Engineering Geology Assessment-Addendum I

Lot 15, Ski Lake Estates No. 3

6640 East 1100 South Huntsville, Utah Job No. 145150

The purpose of this letter is to respond to the geology review comments⁴ provided by Simon Associates, LLC, third-party consultant, hired by Weber County to review the referenced geology assessment letter.

Test Pit 3- West side, middle of the trench.

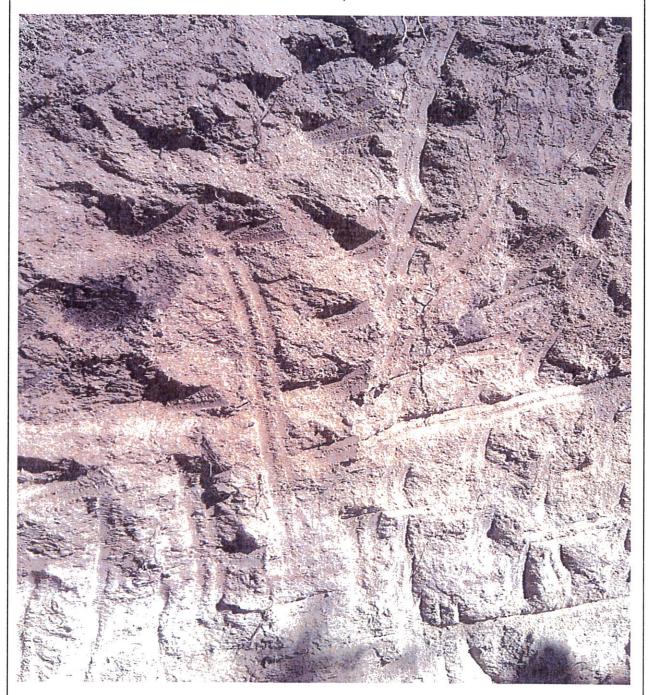
Review Comment 3 states: "On page 5 of the July 13, 2015.EEI report, EEI states: "on June 22, 2015, a geotechnical engineer from Earthtec Engineering returned to the lot with the excavator and oversaw the excavation of an additional test pit (TP-5) in the area of the proposed house on the lot as well as extending TP-3 down slope to the elevation of TP-4. This was done to provide additional subsurface observations in order to better understand the shallow subsurface geology at the site. Test Pit TP-5 and the extension of TP-3 were not logged but were photographed by the engineer." SA recommends Weber County request the annotated photographs of TP-5 and the extension of TP-3 on 6-22-15.

TP-3 was photographed as shown in Exhibit 1 through 3, Appendix A. No photographs of TP-5 were taken, and this test pit was backfilled.
